**RE: Field Issue of CS-PF bracing for Lot #33 Osage - 2105 SW Rutherford Dr, Lee's Summit, MO 64082 – Permit # PRRES20213811**

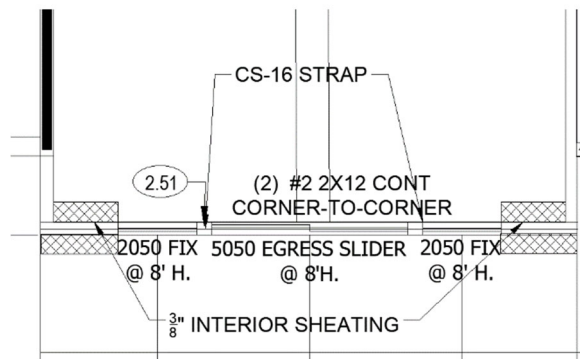
- 2x12 continuous header was installed above top plate in bed #1.
- Bed #1 requires CS-PF bracing per plans.
- Header spans approximately 13.5' and is supporting roof loads.
- Required strapping per CS-PF detail was attached to 2x members.

- Install 3/8" minimum OSB on the interior side of the wall where CS-PF is required in bed #1.
  - Sheathing is only required in bracing locations indicated by hatching.
  - Existing exterior sheathing requires no modification.
- Sheathing shall extend from the bottom plate to the top edge of the 2x12 header.
- Sheathing shall be nailed at 6" OC field and 3" OC edge with 8d nails.
  - Nail pattern shall extend up to top of header.
- Install CS-16 straps on jack studs between windows to 2x12 header.
- See image below.
